## **Proposal for collective amendments to 00, 01 and 02 series of amendments of UN Regulation No. 127 - PEDESTRIAN SAFETY PERFORMANCE**

The text reproduced below has been prepared by the expert from Germany to amend the definitions and specifications as well as the Annex 1, Part 1.

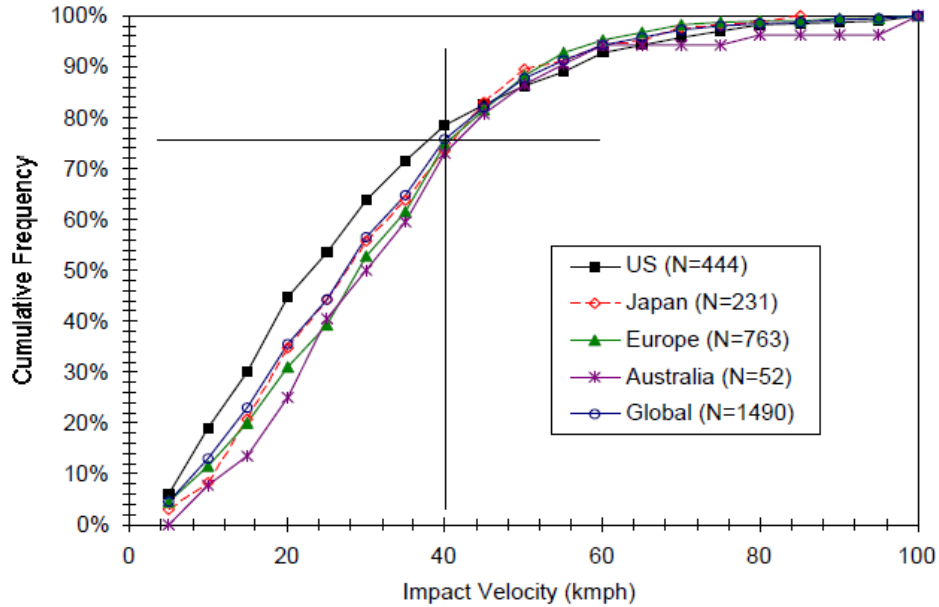
UN Regulation No. 127 addresses impacts with a pedestrian up to 40 km/h. Therefore, an impact velocity of 11.1 m/s (40 km/h) has been chosen to address a large amount of MAIS 1+ pedestrian accidents (see diagram below).
